UNITED STATES PATENT AND TRADEMARK OFFICE

APPLICATION NO.	FILING DATE	FIRST NAMED INVENTOR	ATTORNEY DOCKET NO.	CONFIRMATION NO.
10/821,737	04/09/2004	Jochen Schweinbenz	10191/3610	1521
26646	7590	05/03/2006	EXAMINER	
KENYON & KENYON LLP ONE BROADWAY NEW YORK, NY 10004			PAPE, ZACHARY	
			ART UNIT	PAPER NUMBER
			2835	
DATE MAILED: 05/03/2006

Office Action Summary

DETAILED ACTION

Fig 1

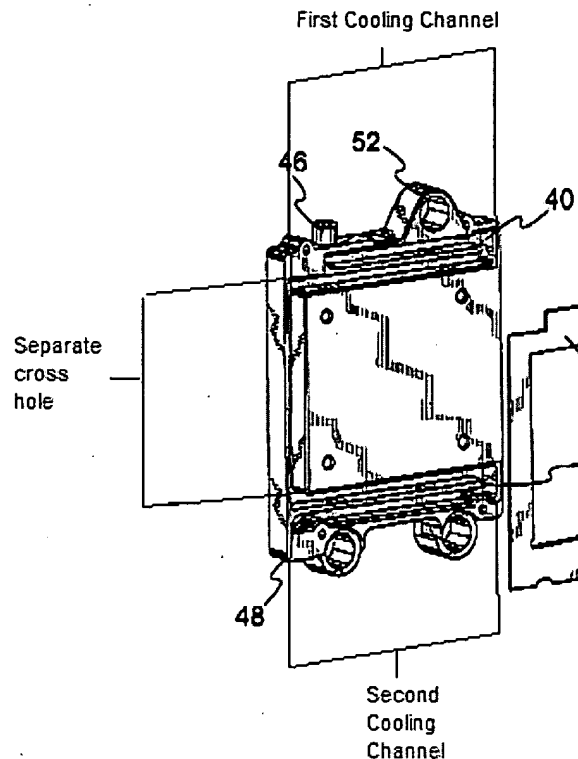
With respect to claim 10, Clamp et al. further illustrates that the separate cooling channels are connected by at least one separate cross hole (Running along the left side of the bottom as illustrated in Fig 2 and present office action Fig 1 below).

With respect to the applicants' remarks to claims 9 and 10 that, "It is obvious that no separate cooling channel is provided, since only one cooling channel is present", the examiner respectfully disagrees. The examiner respectfully notes that Clamp intentionally included several separate cooling channels to, "constrain the fuel to follow a convoluted flow path through the flow conduit to increase residence time and the effective heat transfer from the electronic components". Therefore the flow path (40) is comprised of several separate cooling channels connected by at least one separate cross hole as illustrated in present office action Fig 1 below
